YANKEE ATOMIC ELECTRIC COMPANY

FYR 82-104

Subject: Additional Information for Proposed Change #179

FIGURE 1

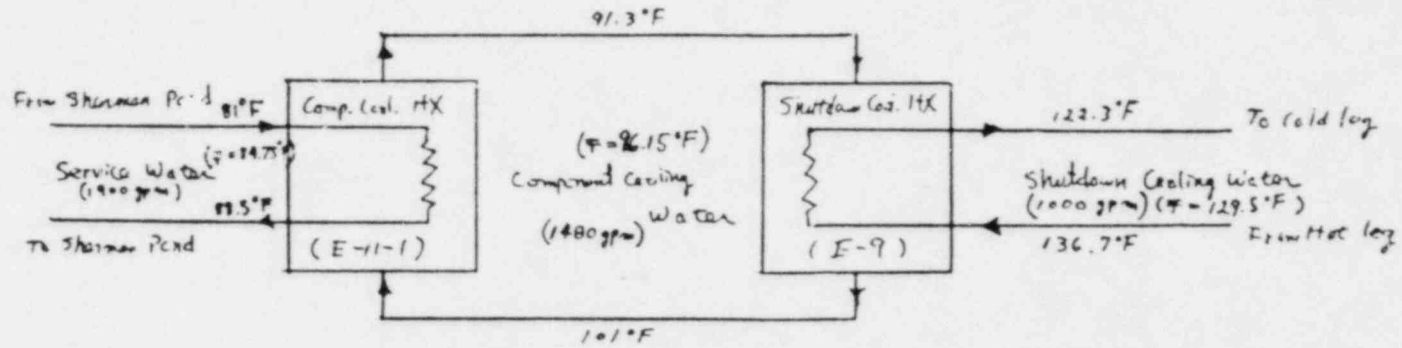
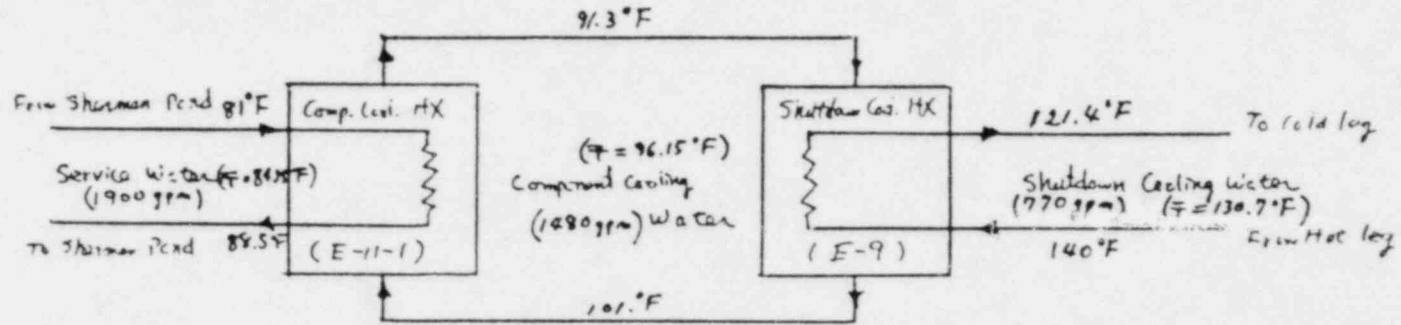
Two different flow rates in the Residual Heat Removal System were analyzed: 1) the minimum available flow rate, and 2) the minimum required flow rate to meet Technical Specification on the maximum vessel water temperature of 140°F. In both cases, a minimum available flow rate in the Service Water and Component Cooling Loops was used. The minimum available flow rate was defined as the flow rate obtained by a pump minus the flow rate through all other paths not directly connected to the heat exchangers removing core decay heat. Inlet and outlet temperatures of both heat exchangers are schematically shown in Figure 1 for both cases. An absolute minimum flow rate in the Residual Heat Removal System was estimated to be 770 gpm, so that a flow rate of 850 gpm would be sufficient to keep the vessel water temperature from exceeding 140°F.

Case: Minimum Available Flow Rates

Case Minimum Required Flow in Shutdown Cooling

The conclusions from this analysis demonstrate that there would be no adverse affect on safety at the reduced flow rate of 850 gpm in the Residual Heat Removal System. Additionally, the analysis demonstrates that 1) a reduced flow rate of 850 gpm is sufficient to keep the maximum reactor vessel water temperature from exceeding the Technical Specification value of 140°F, and 2) stratification of the boron concentration will not occur for a flow rate of 850 gpm.
